Review of proposed solution for Gib Elec LNG terminal

Report for:
Gibraltar Electricity Authority

Report no: 105913-2/R1 Rev: C

Date: 15 October 2015

Figure 5.1 - Risk picture (3 zone map) developed by HSL for Shell's proposed base case

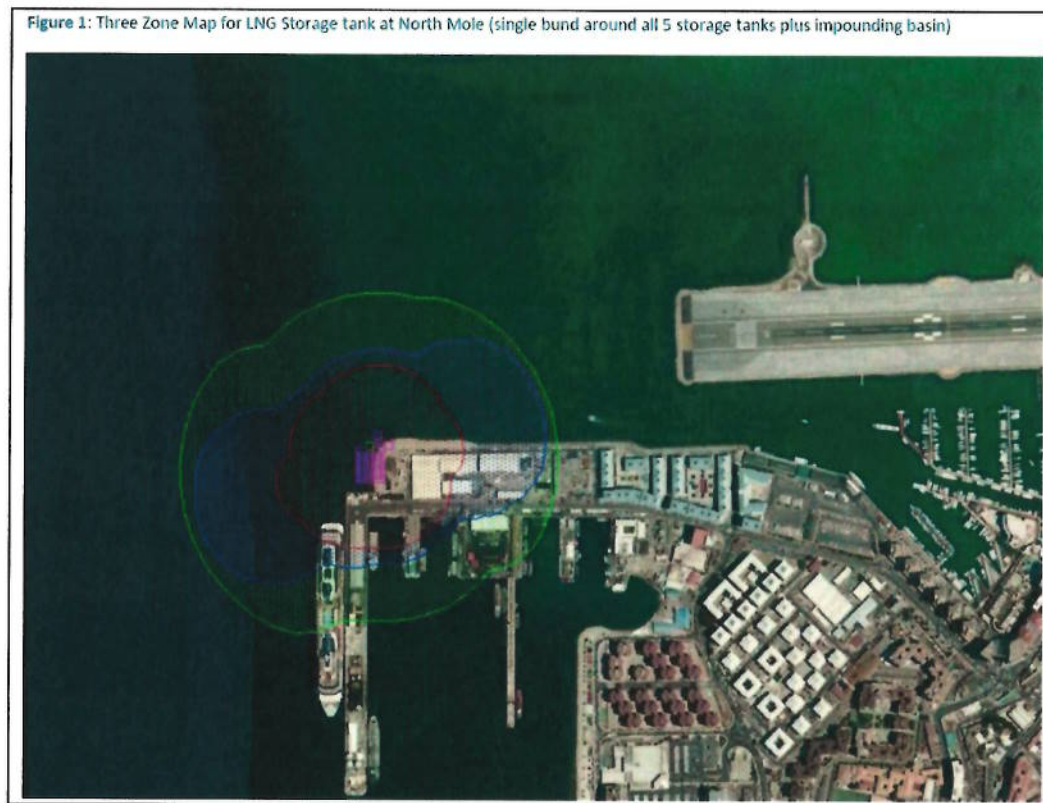
HSL's report shows that the middle (blue) zone does not cover the residential area east of the LNG storage facility proposed location.

A catastrophic rupture of one LNG tank is the worst credible scenario evaluated both in the QRA provided by ERM and HSL. The frequency of this scenario has a relatively large impact on the total risk picture.

The frequency used for the risk contours provided by ERM and HSL applies HSE "lower bound" and "HSE upper bound", respectively. Both choices can be justified; apply the "lower bound" as the tank design is double walled stainless steel tanks or apply the "upper bound" since the project is in an early stage and a conservative approach may be preferred.
